Re: Initial Submission Review – Vistas at Beacon Point – Site Plan/Preliminary Plat Comment Responses

Application Number: DA-1616-09
Case Number: 2019-3046-00

SITE PLAN WITH WAIVERS

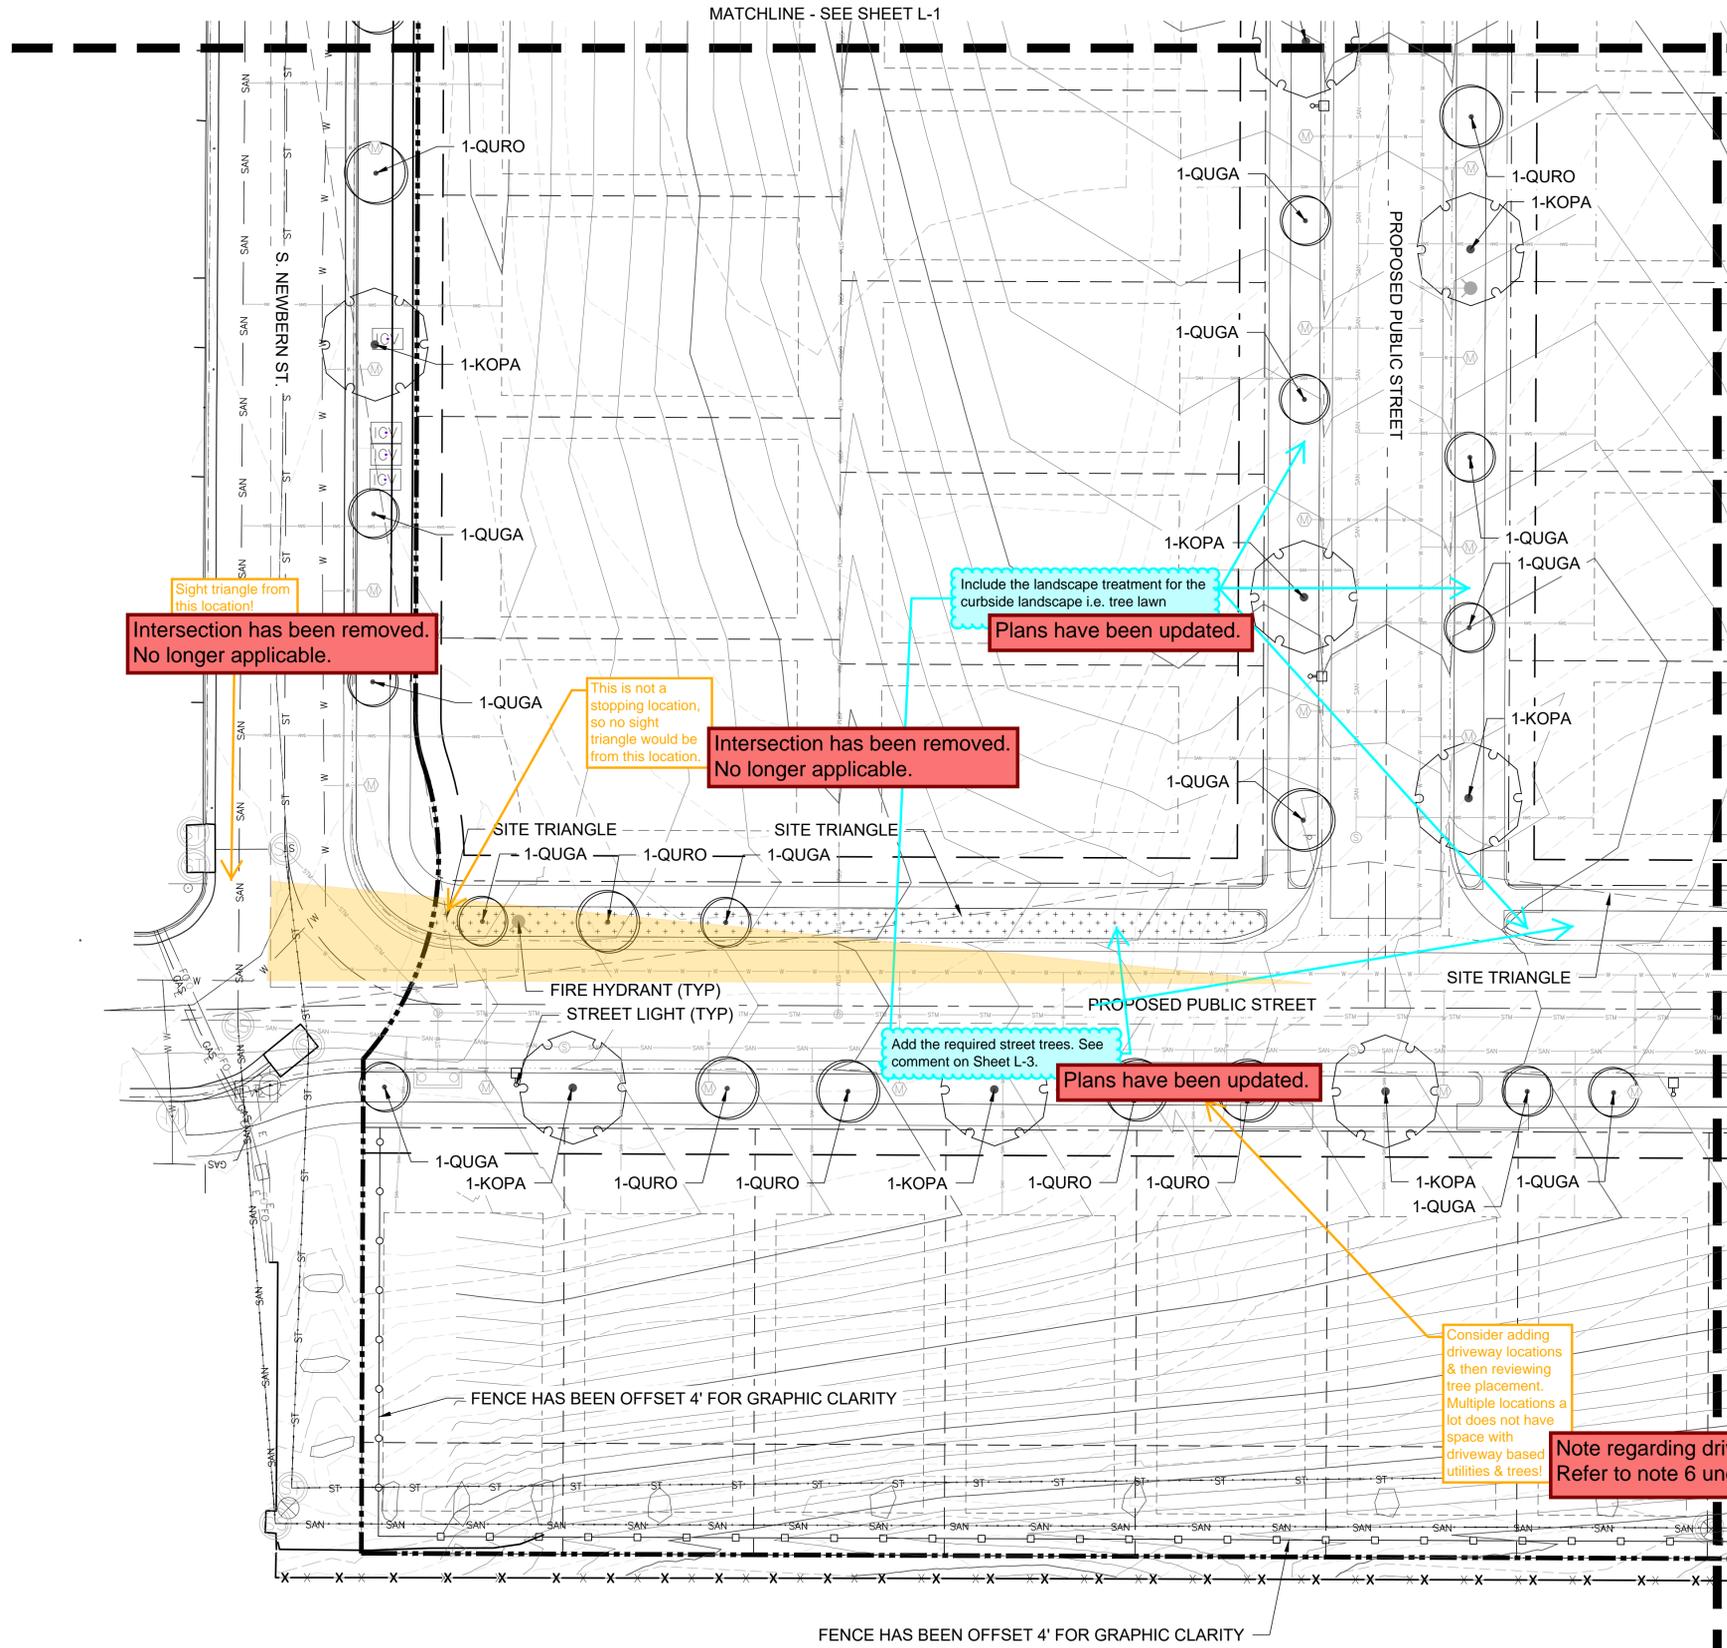
Sight triangle from this location!
 Intersection has been removed. No longer applicable.

This is not a stopping location, so no sight triangle would be from this location.

Add the required street trees. See comment on Sheet L-3.
 Plans have been updated.

Note regarding driveway placement has been added. Refer to note 6 under "General Notes" on sheet L-5.
